EL PASO COUNTY FILE NO.: PUD SP-22-006

# VILLAGES AT STERLING RANCH

## DEVELOPMENT PLAN & PRELIMINARY PLAN

# V3\_PUD Development Plan - v3 new design comments.pdf Markup Summary

PUD DEVELOPMENT PLAN  
& PRELIMINARY PLAN

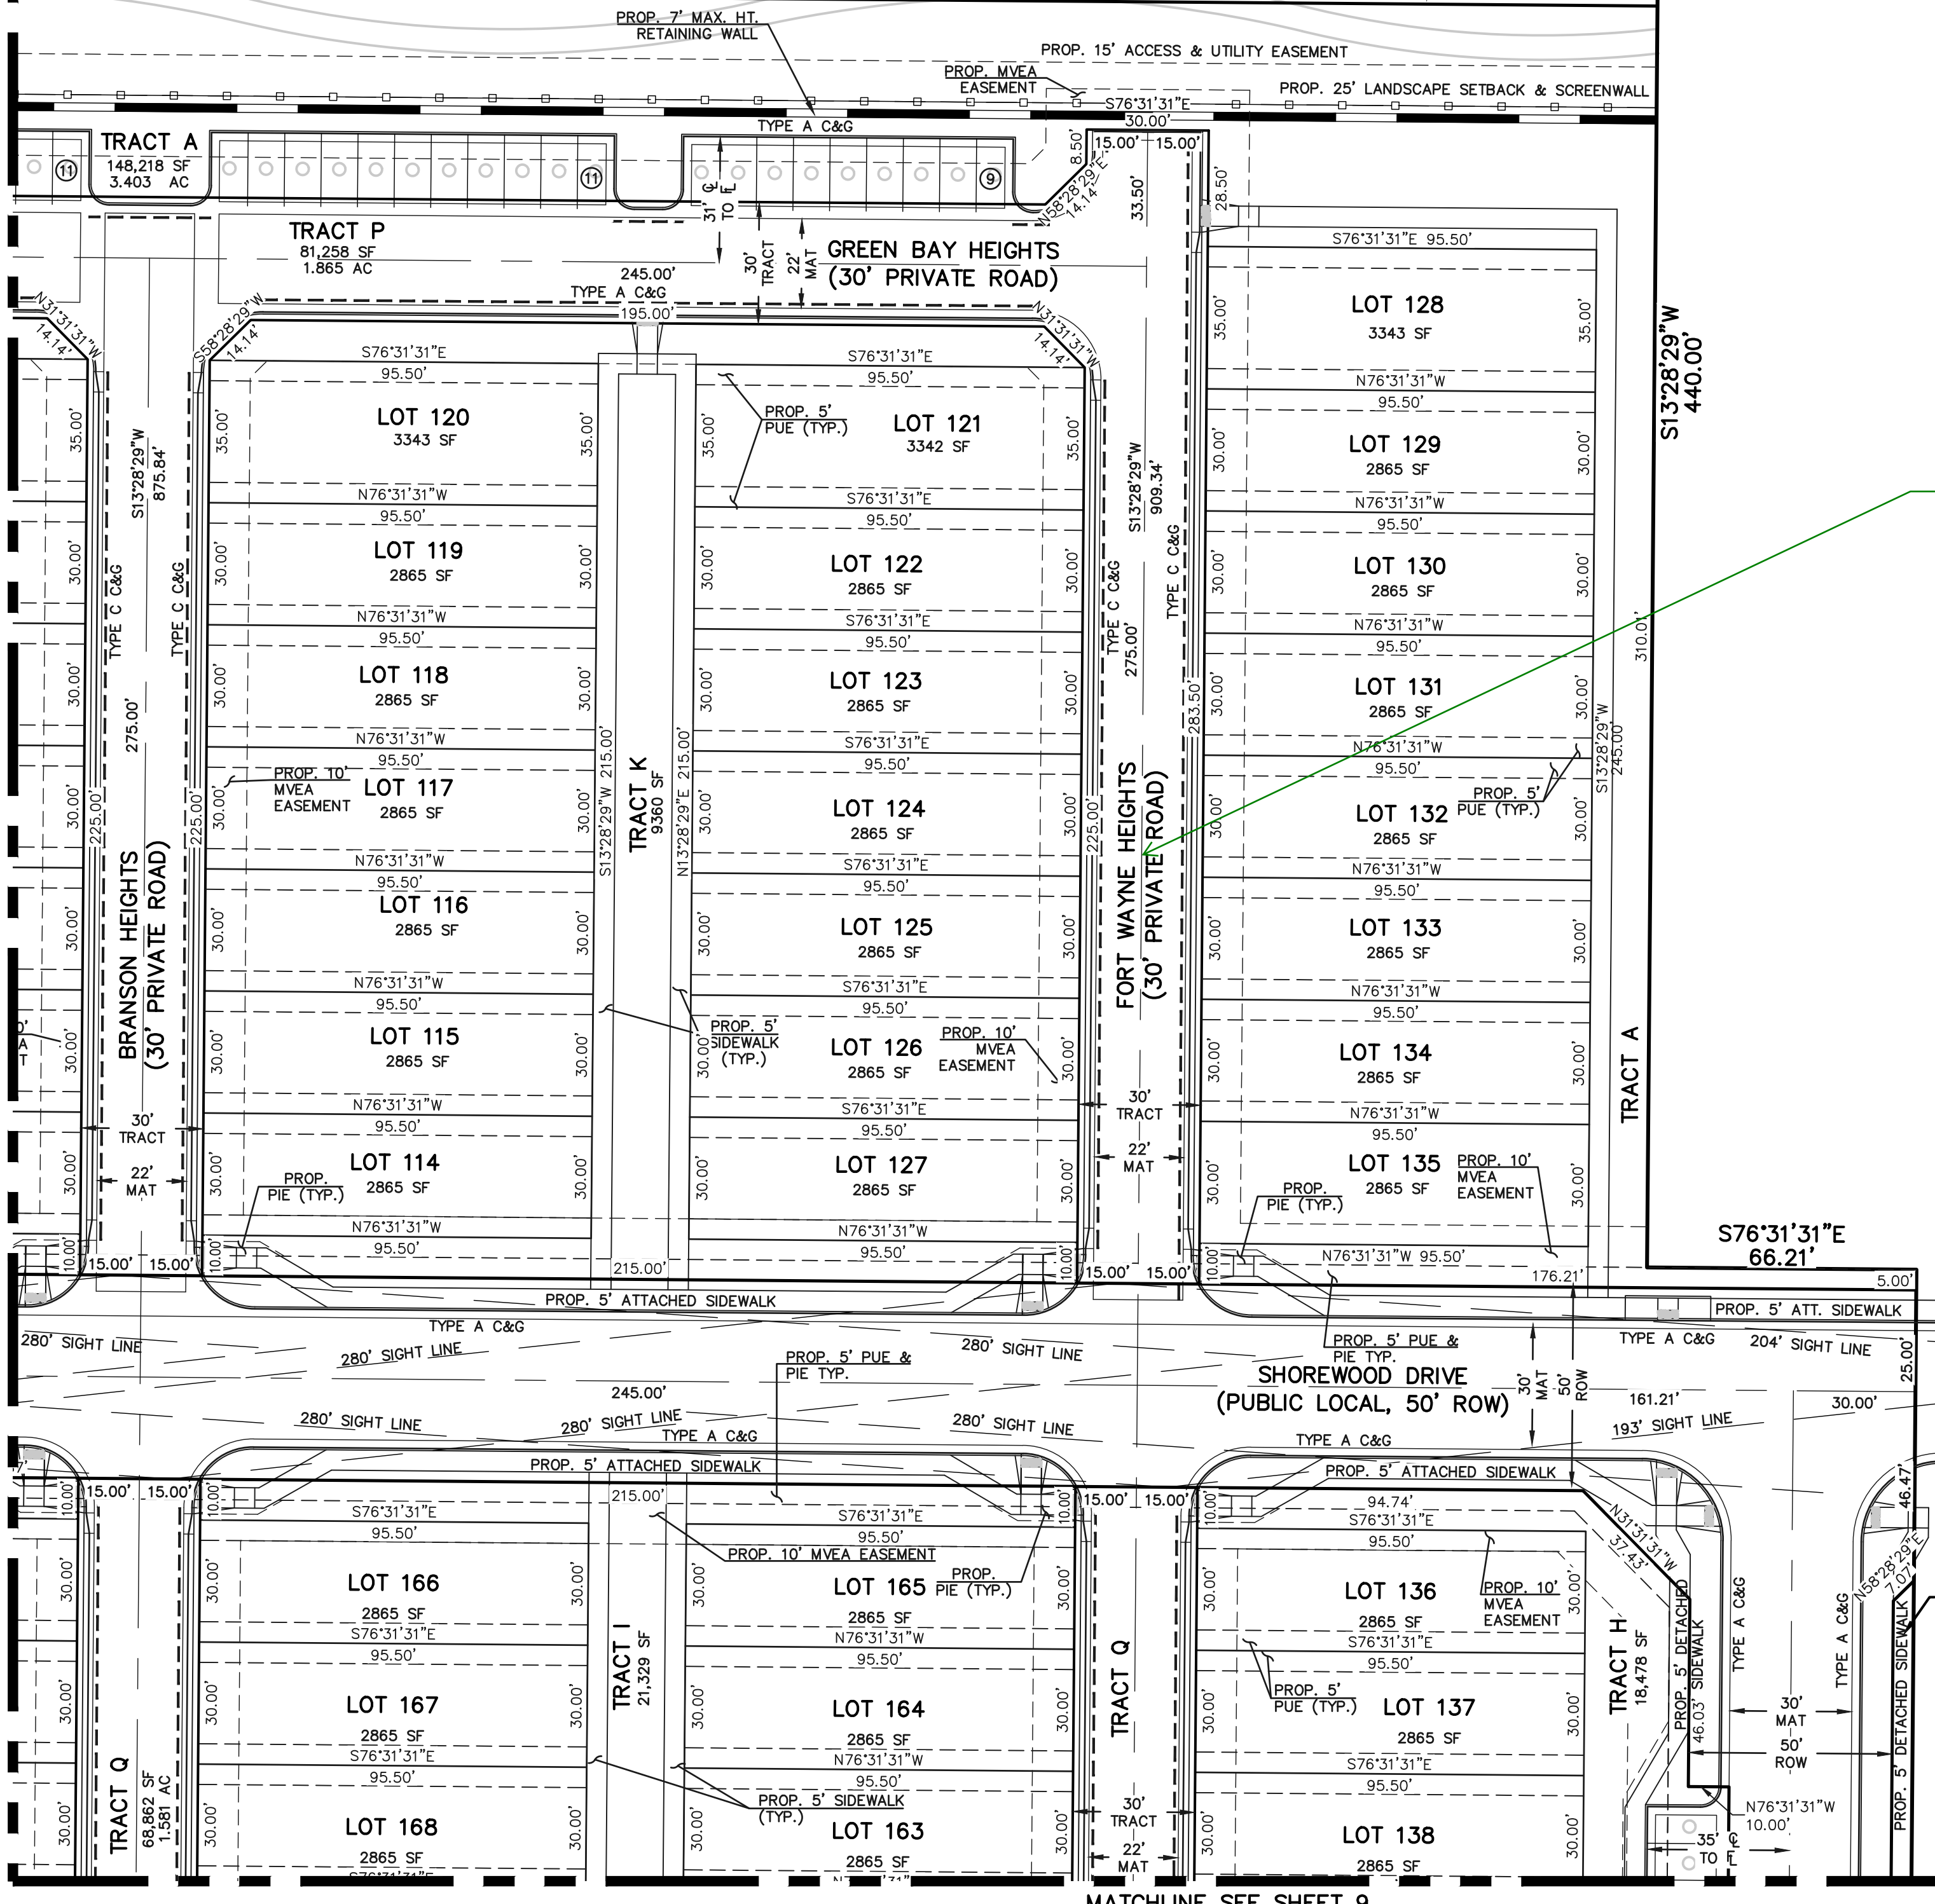
Identify no parking  
sign symbols on  
private roads- all  
sheets?

approved density? current  
zoning- see checklist add  
missing items. Zoning can  
be adjacent not 500-feet

PUD DEVELOPMENT PLAN & PRELIMINARY PLAN

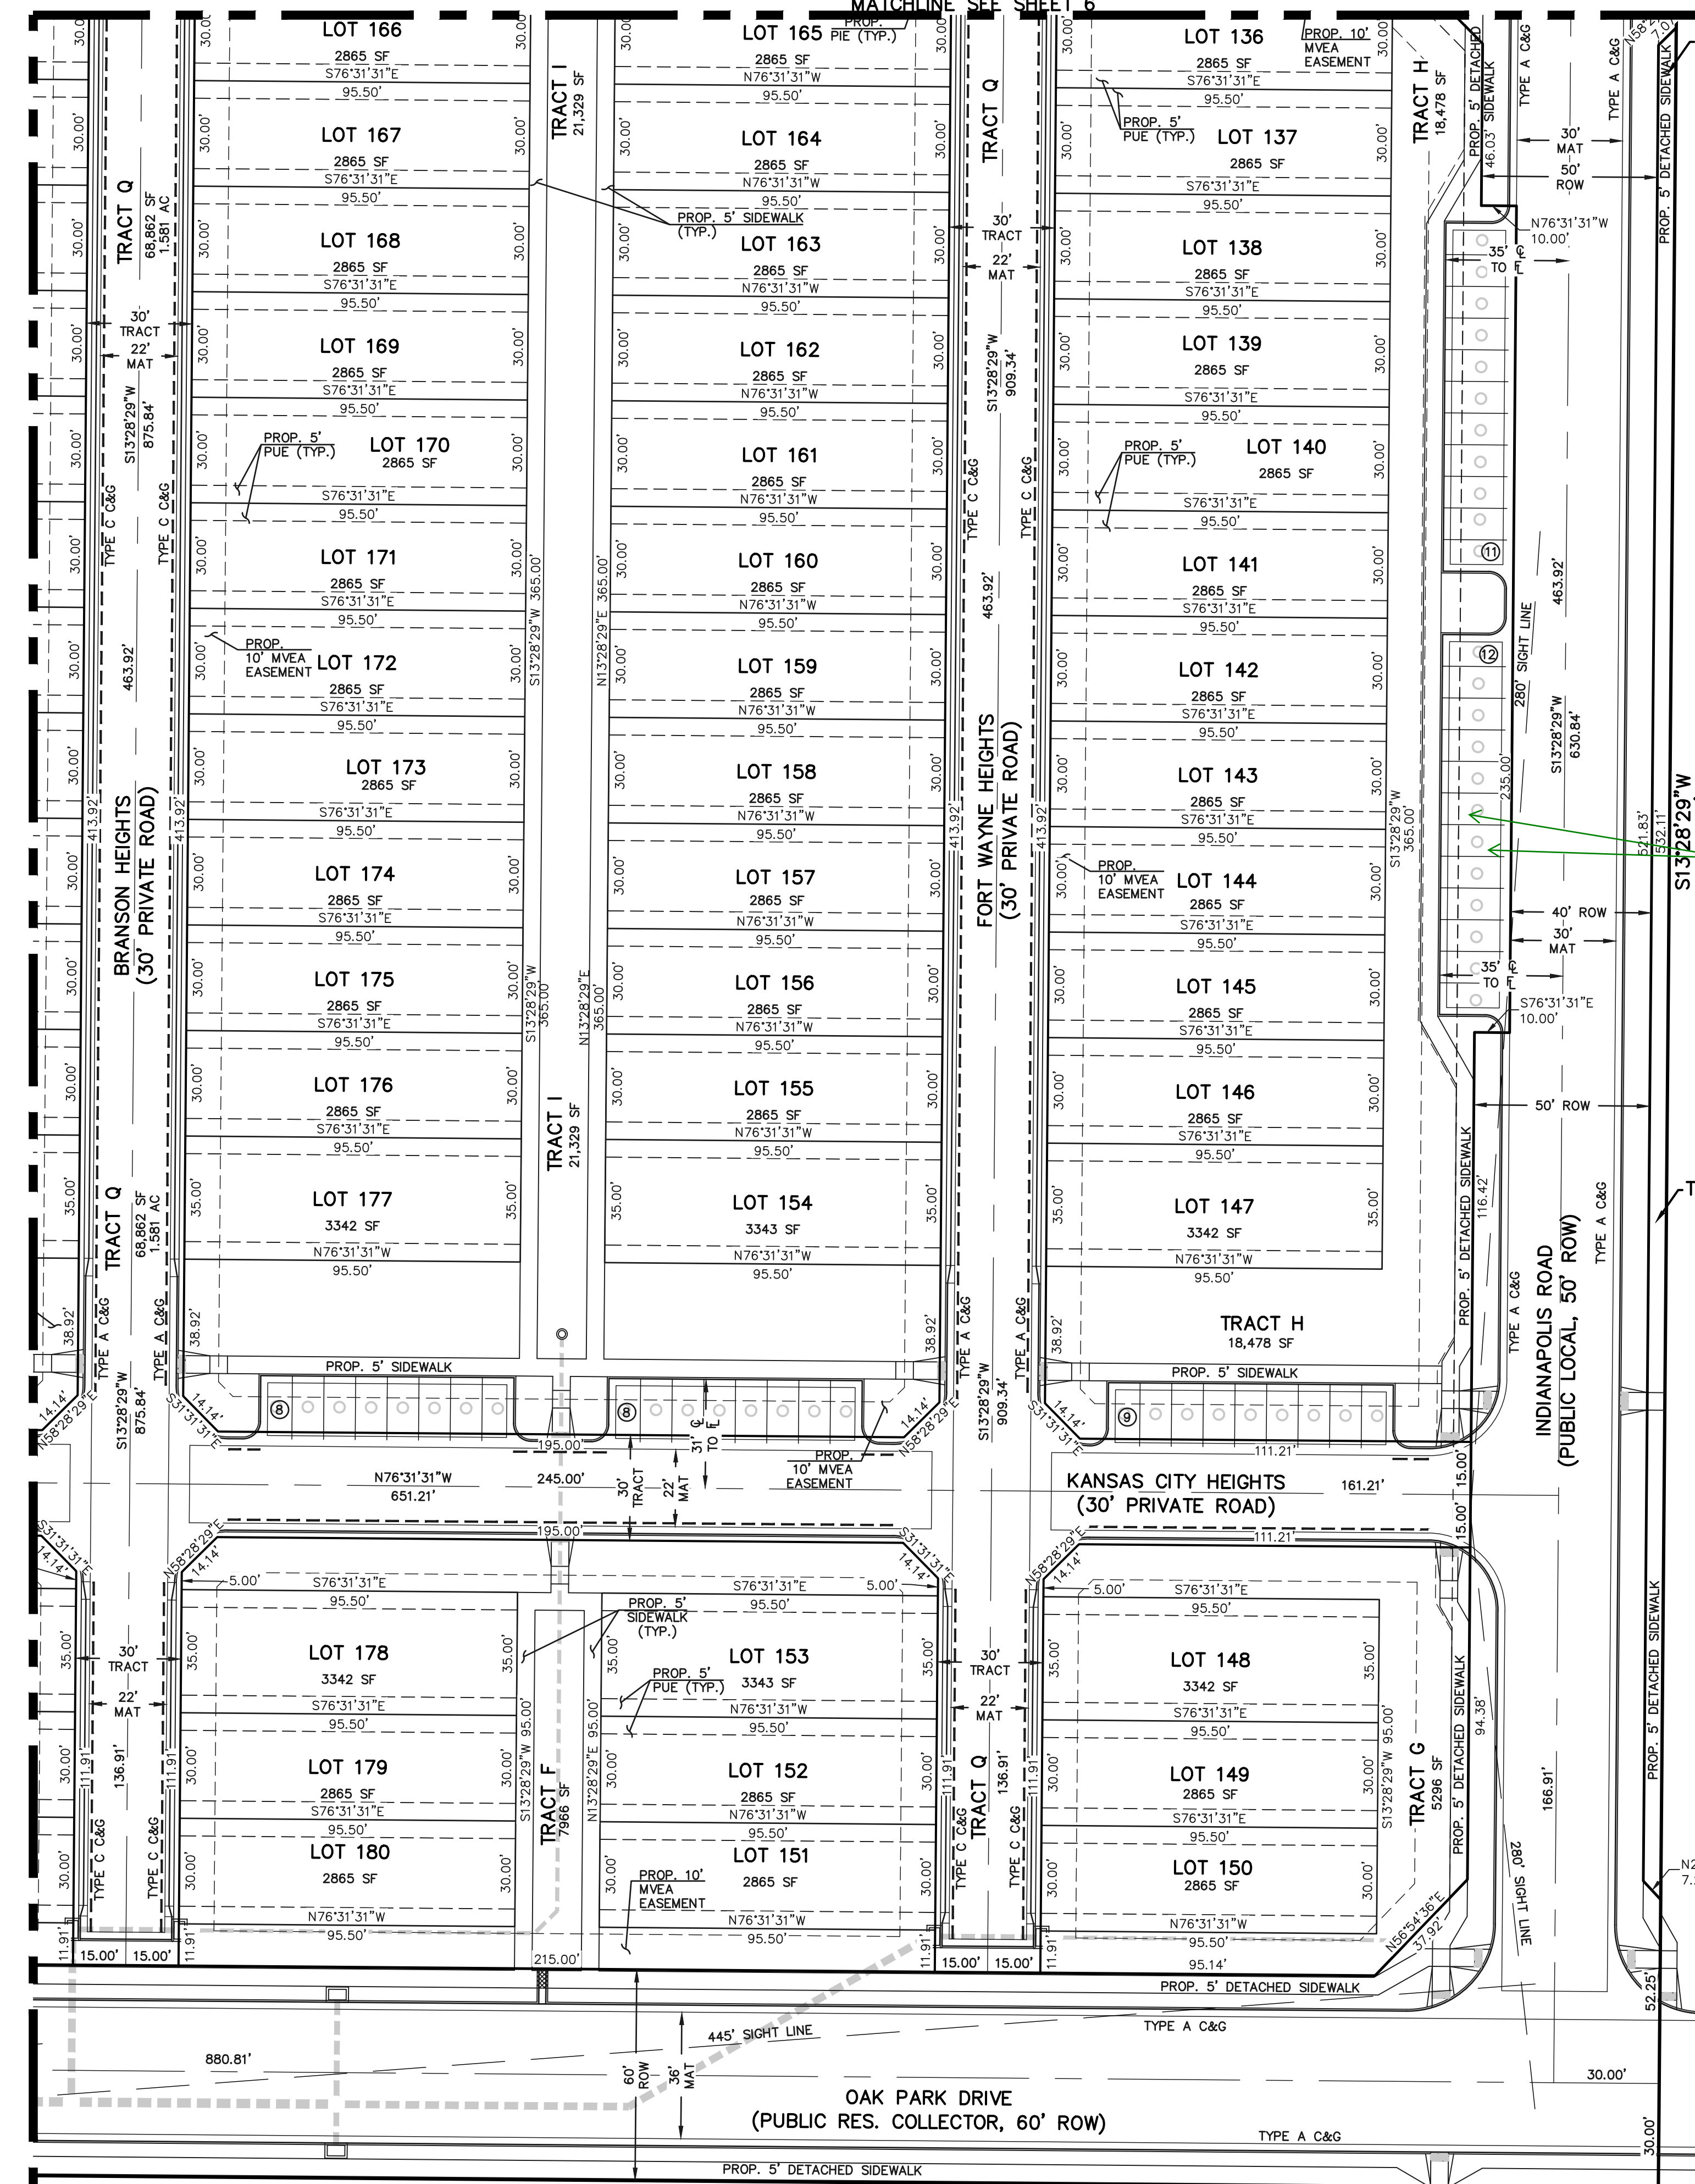
ADA Parking required based on number of spaces per Code;  
 Add modification for parking back into to public row needed (we talked about this and agreed to modify standards)

6.2.5.C.3.(g) No Backing into Public Right-of-Way. No vehicle leaving a parking space shall be allowed to back into a public right-of-way.

dimension these so we verify no hangover into ROW multiple places in Plan

Repeat Comment ADD checklist missing items PUD and Prelim please verify and add like adj prop info (Add SKP density). 500' not required just adjacent

VILLAGES AT STERLING RANCH  
 PRELIMINARY GRADING AND UTILITY PLAN

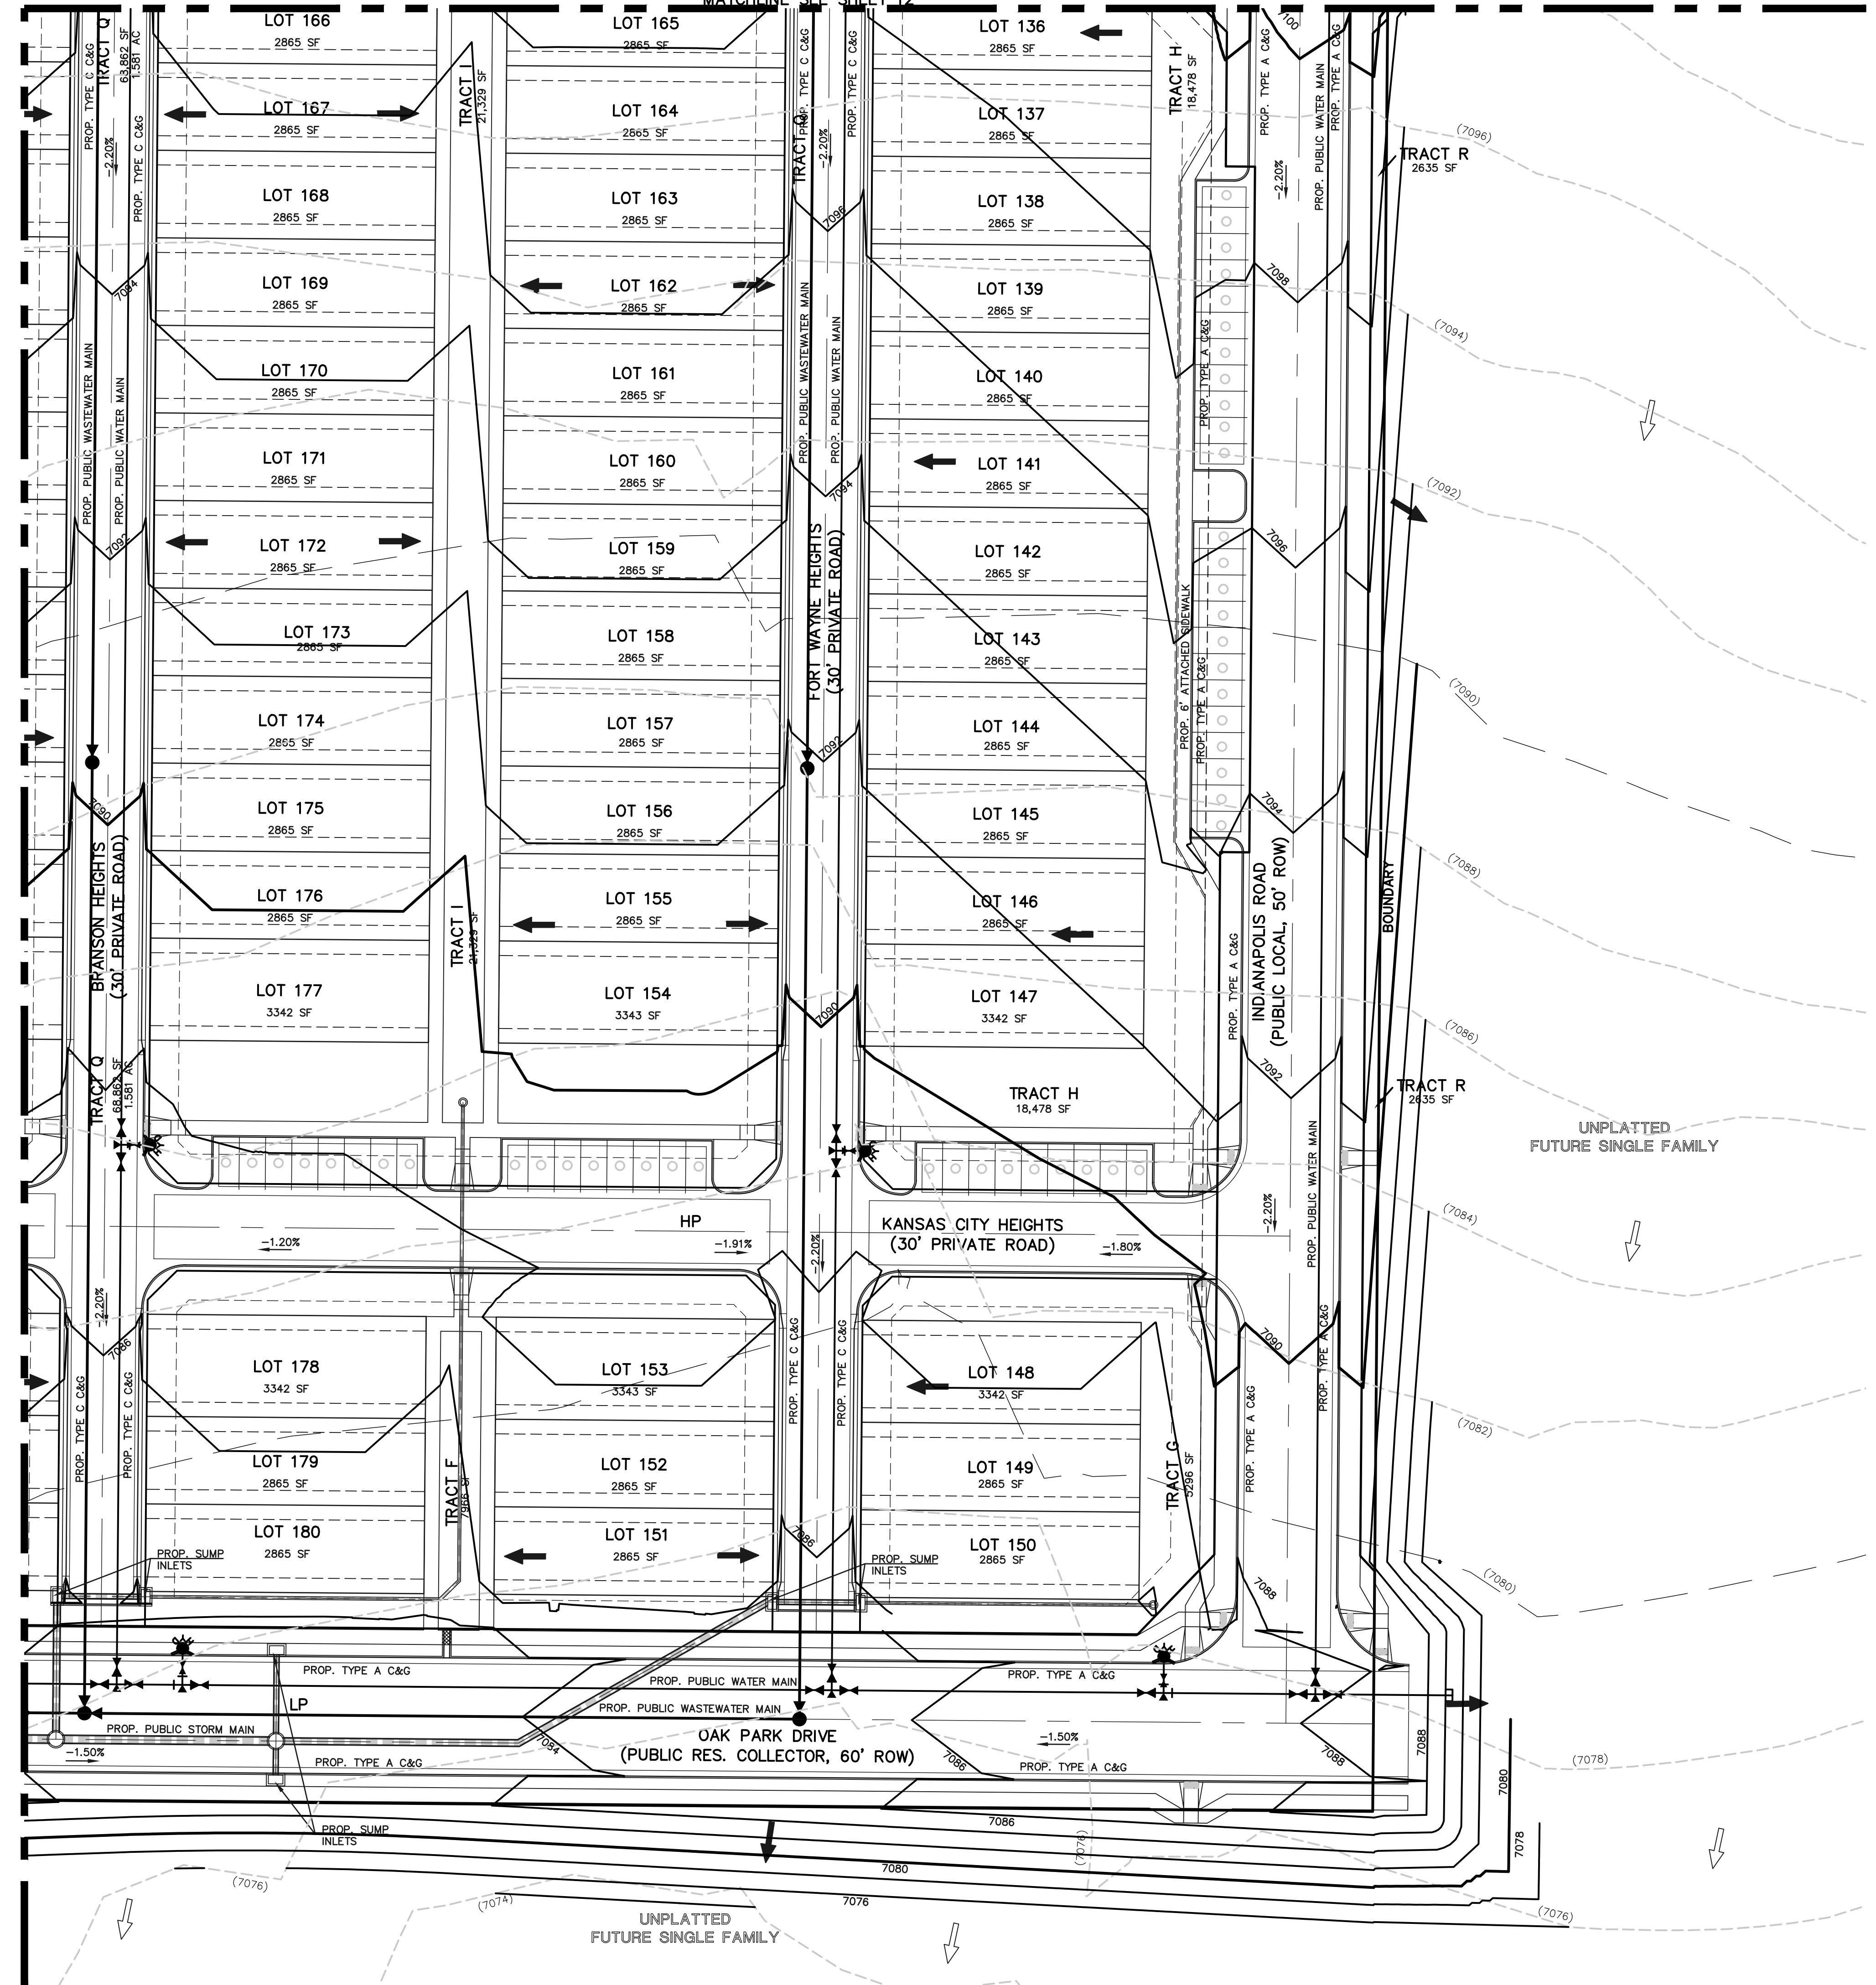
Unresolved:  
 Include that grading sheet that included the pond that was part of the previous submittal  
 Include all offsite grading that will need to be done to get project flows to proposed pond at south end of SRE Filing 5.

The Landscape Plans are not here?
